Subject: Duke Energy Corporation (Duke)
McGuire Nuclear Station Units 1 and 2
Docket Numbers 50-369 and 50-370
Technical Specifications Amendment
Request for Additional Information (RAI); TS 3.7.15 -
Spent Fuel Assembly Storage, and TS 4.3 - Fuel
Storage

Responses to Nuclear Regulatory Commission Request for Additional Information Related to McGuire Nuclear Stations's License Amendment Request for No-Boraflex Credit

Figure 11.1. McGuire SFP Region 2 Storage Rack – Heterogeneous Model

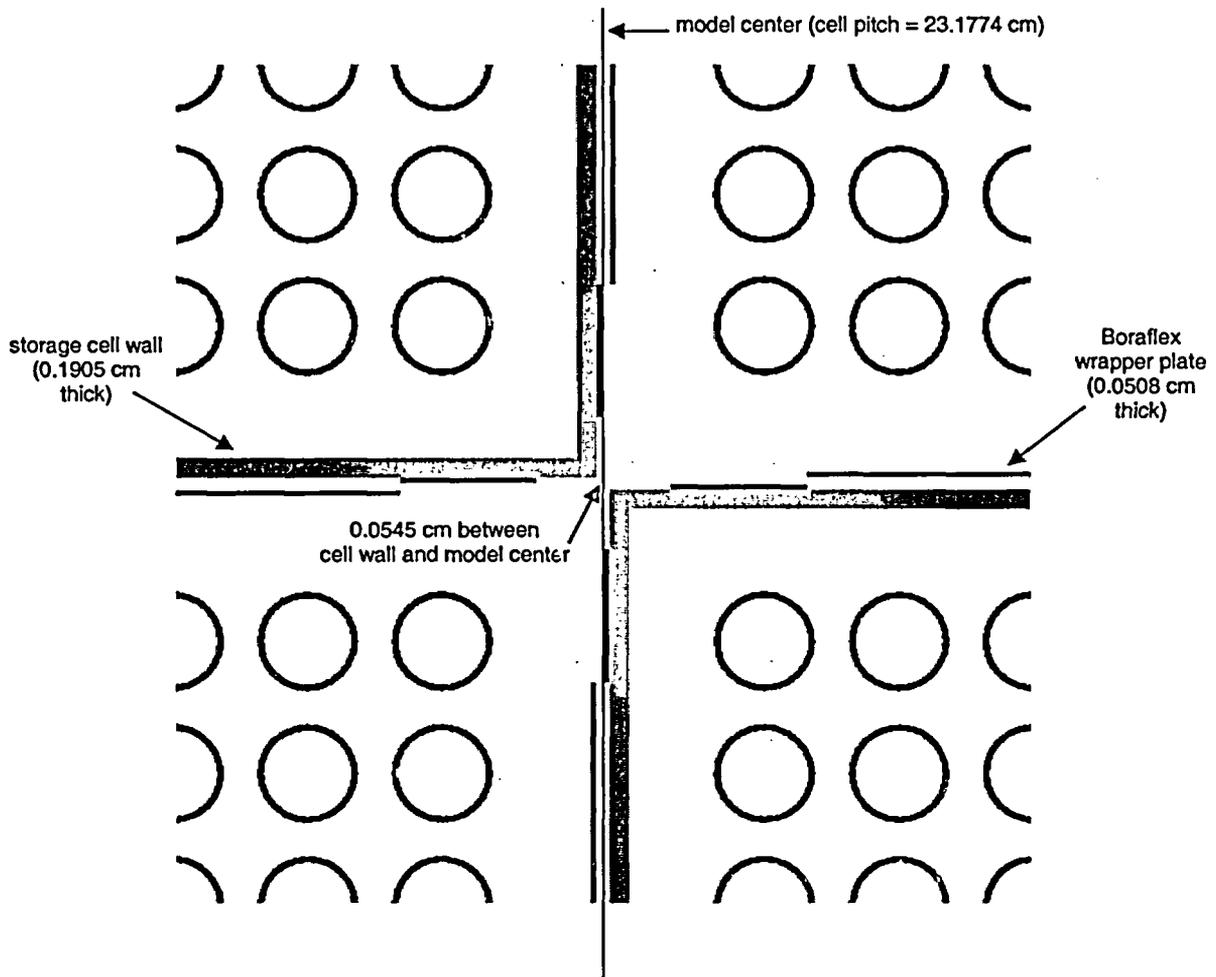
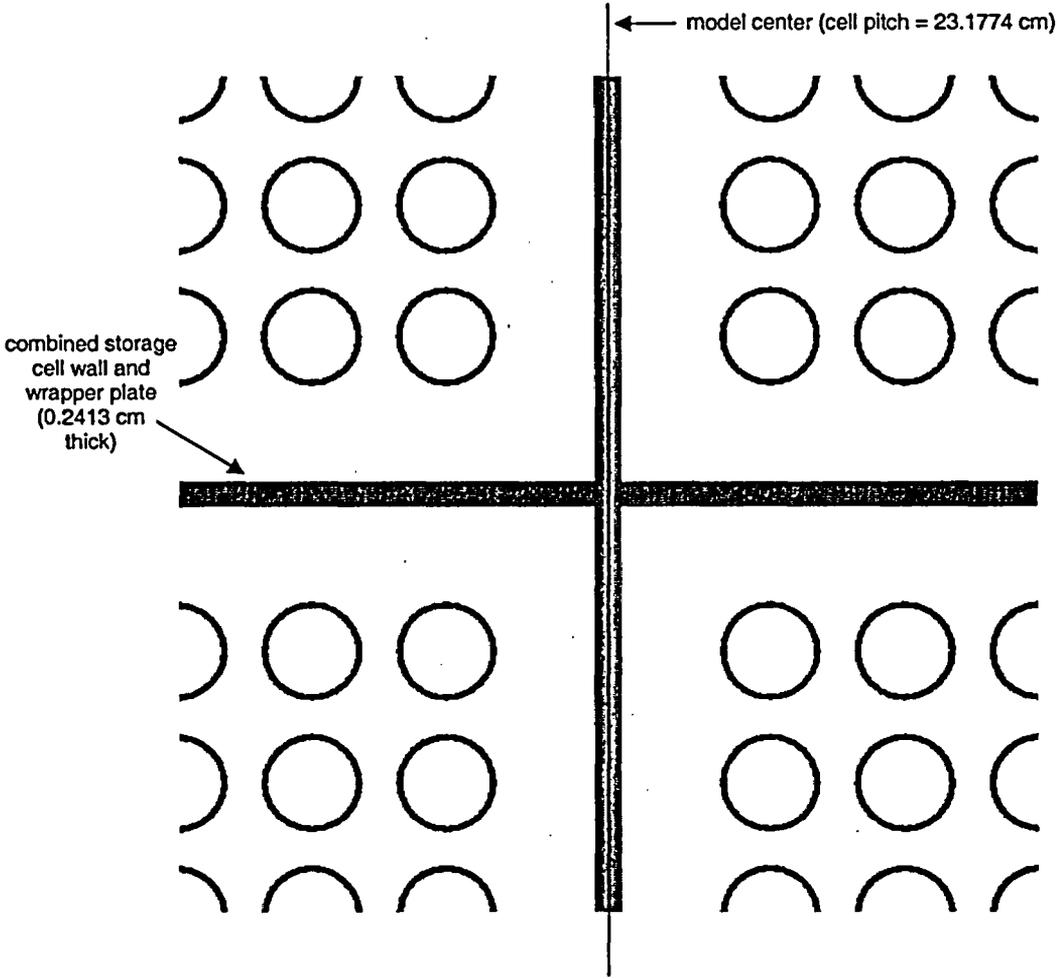
In Section 8.2, "SFP Region 2 Criticality Analysis," of Attachment 6, the licensee described how it homogenized the Region 2 rack model for analysis using CASMO-3. To accomplish this, the licensee stated that the cell wall location was adjusted in the model to be located at the midpoint between the stored assemblies; thereby, making neighboring cells identical to each other. This change affects the amount of moderator directly adjacent to each assembly. Please describe in greater detail how the dimensions of the model differ from those of the actual racks. In Table 8, the licensee provided a limited set of comparison calculations which show significant variability between KENO V.a heterogeneous and homogenous models and a CASMO-3 homogenous model. The most bounding rack analysis varies based on model used, fuel type, and enrichment. This table fails to demonstrate that the licensee's CASMO-3 homogenous model conservatively bounds either the KENO V.a homogenous or heterogeneous models for varying fuel types and enrichments. Therefore, please evaluate the reactivity difference between an actual rack loaded with fuel of the highest permissible reactivity and the homogenous model rack loaded with fuel of the highest permissible reactivity. Also, please provide sufficient information to demonstrate that the model conservatively bounds the actual rack design for all fuel types and enrichments.

The heterogeneous (actual) Region 2 storage rack model is shown in Figure 11.1. Note that for most of the radial length of the Boraflex wrapper plate there is a gap between the plate and the storage cell wall. Because no credit was taken for any remaining Boraflex material that would be present in these gap areas, water was modeled there for the SFP criticality analysis.

To allow CASMO-3 and SIMULATE-3 to model the Region 2 storage rack, the thicknesses of the wrapper plate and the storage cell wall were combined, the water gap was eliminated, and the combined stainless steel cell structure was centered between the fuel assembly storage locations – see Figure 11.2.

To assess the validity of "homogenizing" the Region 2 rack in this manner, 2-D fresh fuel SCALE 4.4 / KENO V.a cases were run for both the heterogeneous and homogeneous rack model. These cases considered three different fresh fuel enrichments (1.08, 3.00, and 5.00 wt % U-235) for three different fuel assembly designs (W-RFA, W-OFA, and MkBI). The 1.08 wt % U-235 enrichment was chosen because it yielded the highest permissible reactivity – maximum 95/95 $k_{eff} < 1.0$ in unborated water – for Unrestricted fresh fuel storage of the most reactive fuel type in McGuire Region 2. Note that the W-STD and MkBW fuel designs were not included in these evaluations because, for a 2-D slice, the W-RFA design is neutronically similar to these fuel types.

For comparison to these heterogeneous and homogeneous KENO V.a calculations, CASMO-3 cases were carried out with the Figure 11.2 homogeneous Region 2 rack model. The base k_{eff} results from all the computations are presented in Table 11.1. Calculations for all cases were performed at both 32 and 150 °F. The higher of the computed k_{eff} s at these SFP temperature bounds is shown in the Table 11.1 data. Note that SCALE 4.4 / KENO V.a gives nearly the same average k_{eff} s (within $0.0004 \Delta k$) for the heterogeneous and homogeneous Region 2 rack models, for all enrichments and fuel designs. In general, the KENO V.a homogeneous model is slightly conservative (by an average $0.0002 \Delta k$ for the nine enrichment / fuel type combinations in Table 11.1), as desired. No trends were observed, with respect to fresh fuel enrichment, fuel type, or temperature, in the KENO V.a homogeneous-to-heterogeneous model comparisons.

Table 11.2 provides a comparison of the CASMO-3 and KENO V.a results for the 1.08 wt % U-235 cases from Table 11.1, on a total 95/95 k_{eff} basis. The pertinent bias and uncertainty contributors listed in this table were documented in Section 6 of Attachment 6 to the LAR. Table 11.2 demonstrates that on a 95/95 basis, for fresh fuel of the maximum permissible reactivity, the CASMO-3 homogeneous Region 2 rack model is slightly conservative relative to either the homogeneous or heterogeneous KENO V.a model.
